**MINUTES  
PLANNING COMMISSION  
CITY OF LAKEWOOD  
12650 DETROIT AVENUE  
AUDITORIUM  
NOVEMBER 7, 2024  
6:00 P.M.  
RECORDED**

**4. Docket 11-42-24**

**Lake-Clifton Connector Project (Cuyahoga County): Resolution No. 2024-68**

**ARCHITECTURAL SITE PLAN**  
1" = 20'-0"

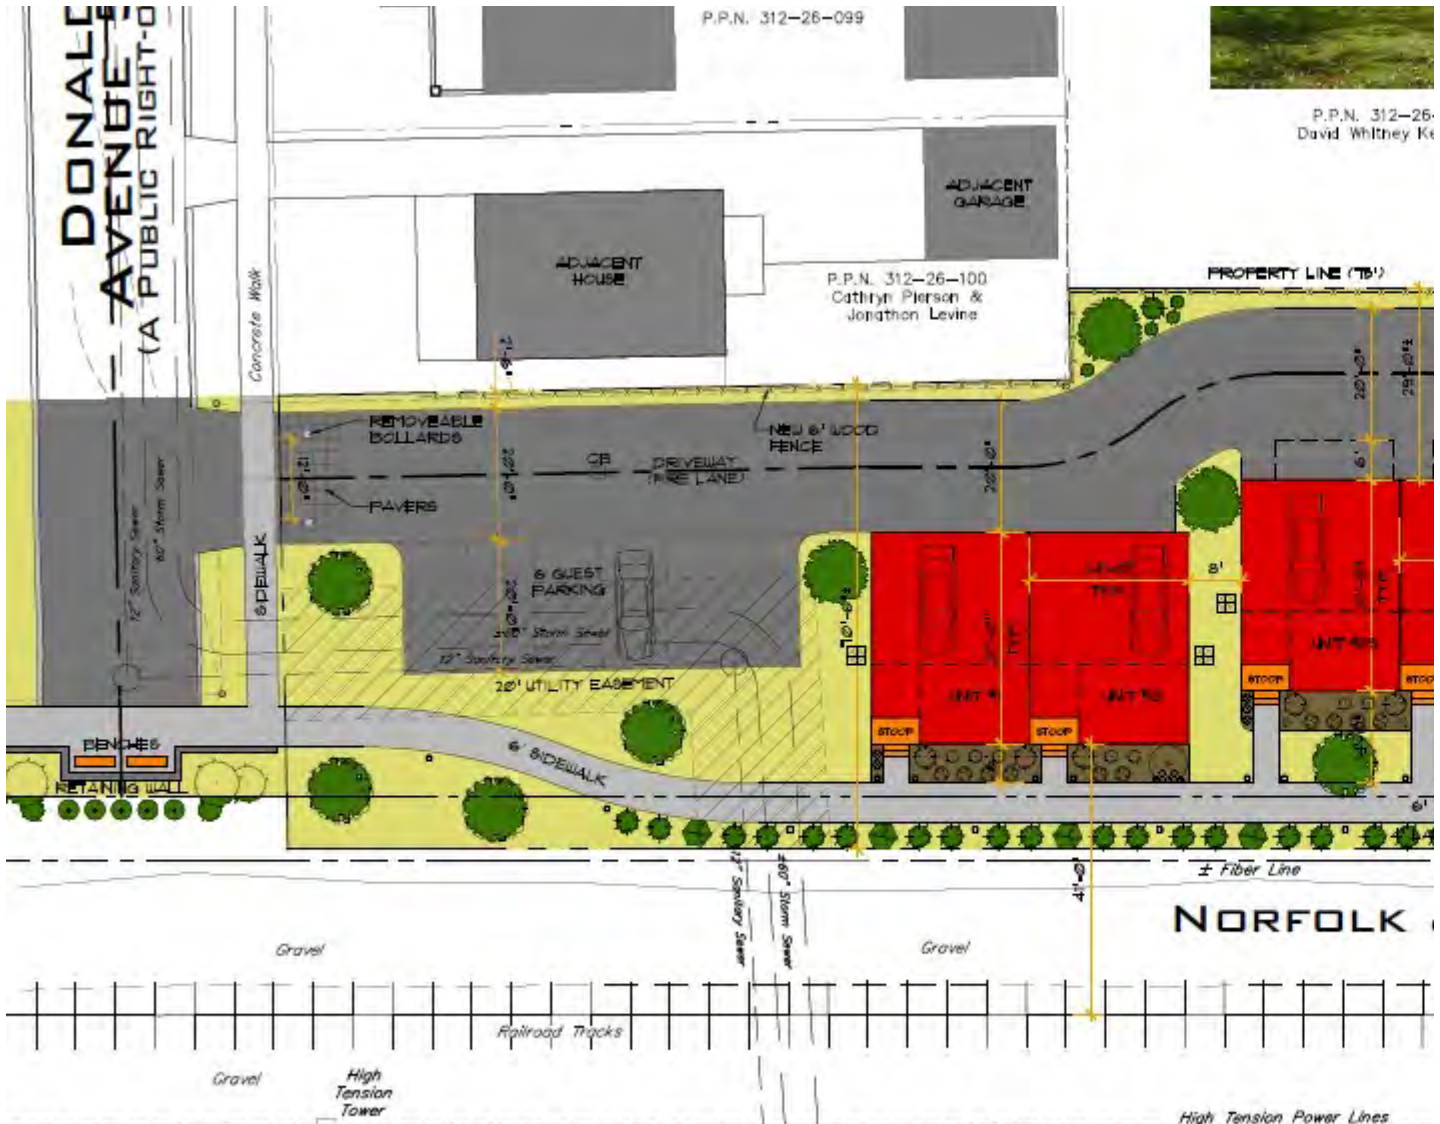
Unfortunately, the latest plans (images below) have not taken into consideration any of the suggestions from the neighbors. We've asked that the road and housing be switched around so that the road would run along the railroad. The latest drawing below shows that they haven't been willing to take that into consideration. Additionally, we've asked that a larger landscape buffer be included, but this has actually been reduced to allow for now a wider two-way street. My understanding is that the buffer dimensions do not fall within the existing code. I also wonder if a street is added why it wouldn't be one-way letting out on Donald to reduce safety concerns of the nearby Cove Park entrance?

**ARCHITECTURAL SITE PLAN**

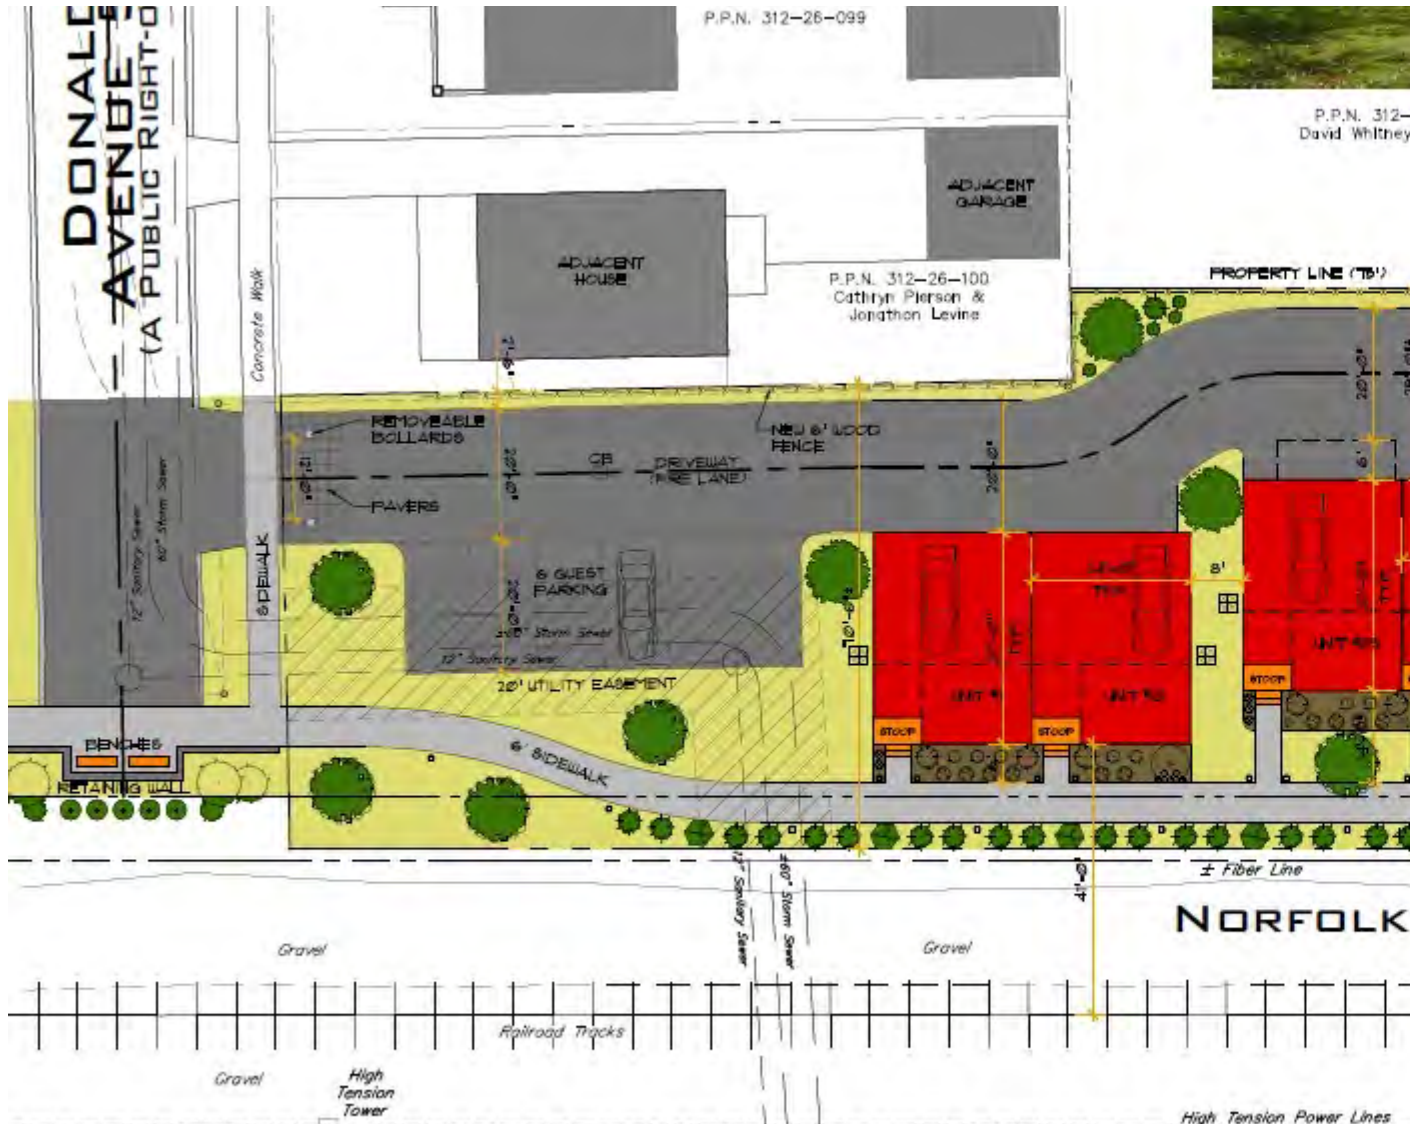
Unfortunately, the latest plans (images below) have not taken into consideration any of the suggestions from the neighbors. We've asked that the road and housing be switched around so that the road would run along the railroad. The latest drawing below shows that they haven't been willing to take that into consideration. Additionally, we've asked that a larger landscape buffer be included, but this has actually been reduced to allow for now a wider two-way street. My understanding is that the buffer dimensions do not fall within the existing code. I also wonder if a street is added why it wouldn't be one-way letting out on Donald to reduce safety concerns of the nearby Cove Park entrance?

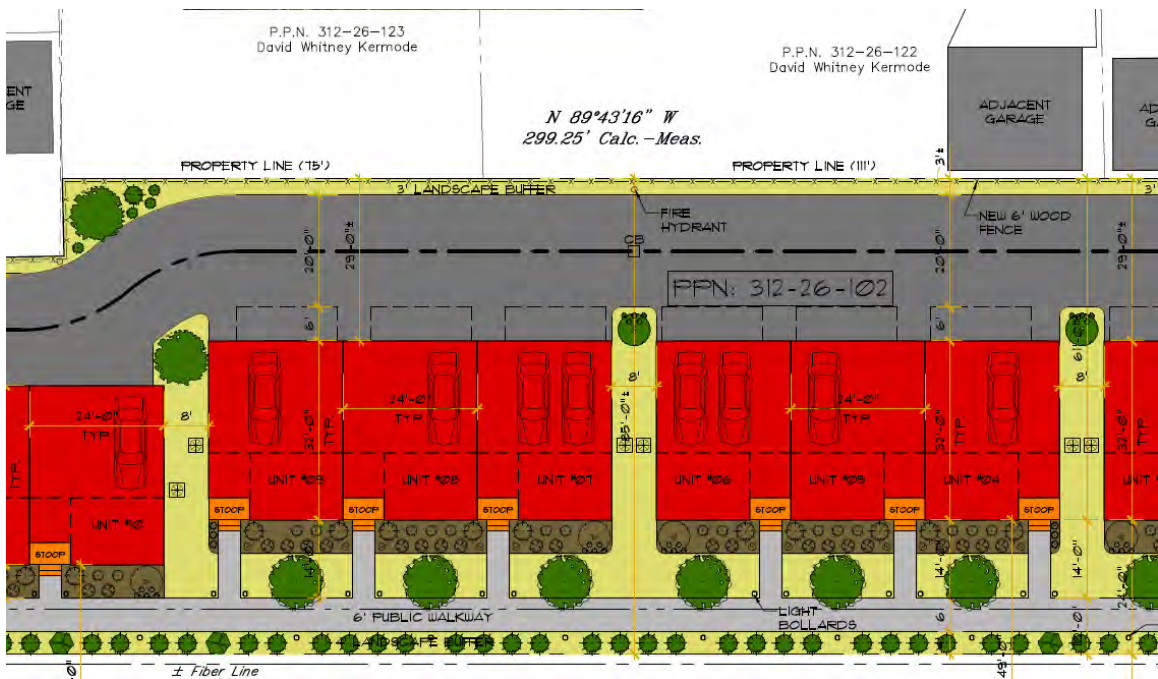
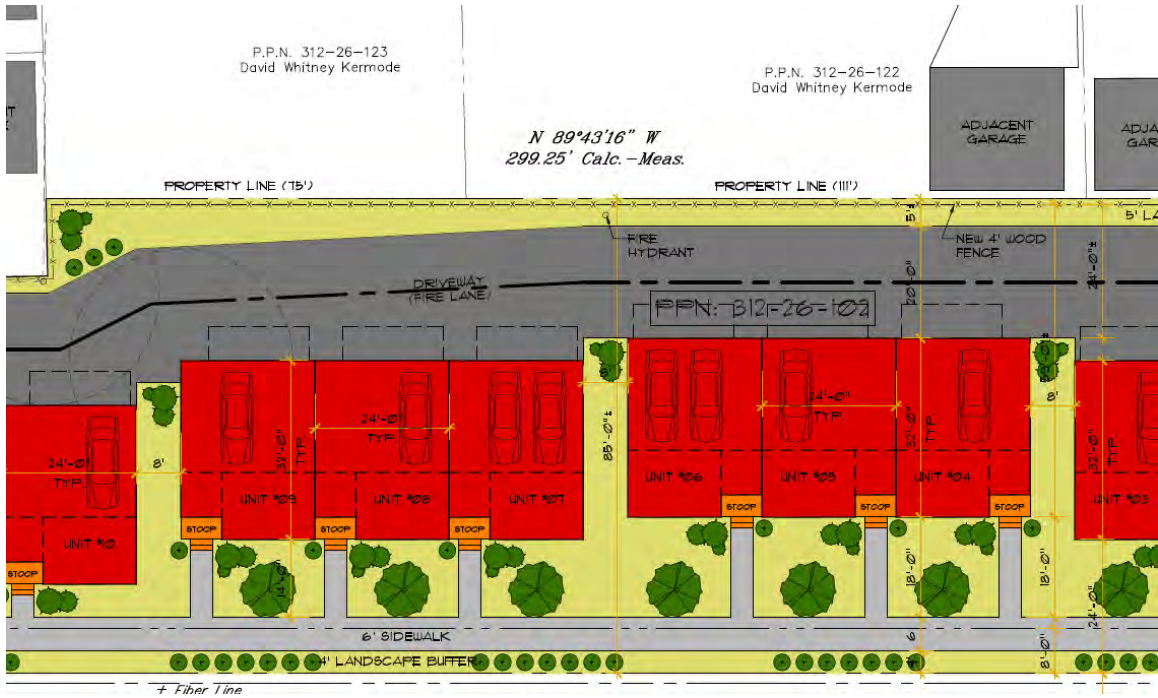
When opening the latest set of plans, it appeared to specifically make worse clearly conveyed areas of concern including the width of the buffer (5' to 11' as of the plan prior to the meeting, now reduced to 3' without any landscaping apart from grass seed) which was requested to be widened to account for spillover impacts of road salting on neighboring landscape that's more heavily impacted, along with vertical planting in excess of the fence height to mitigate the elevated balconies that have very clear viewsheds over the majority of my home and yard, including my own landscaping. That was left out entirely.

- My submitted feedback has noted concerns regarding the interface between the property boundaries. My previous comment noted that the approximately 5' to 11' foot (running from east to west) boundary was inadequate. The revised plan now reduced this further to 3'. I would hope the commission could more forcefully push back on the applicant on that point and good faith efforts to engage with contiguous property owners on material and detrimental impacts created solely by the development as proposed. The following shows the evolution of the plan despite this specific issue being raised with the applicant.
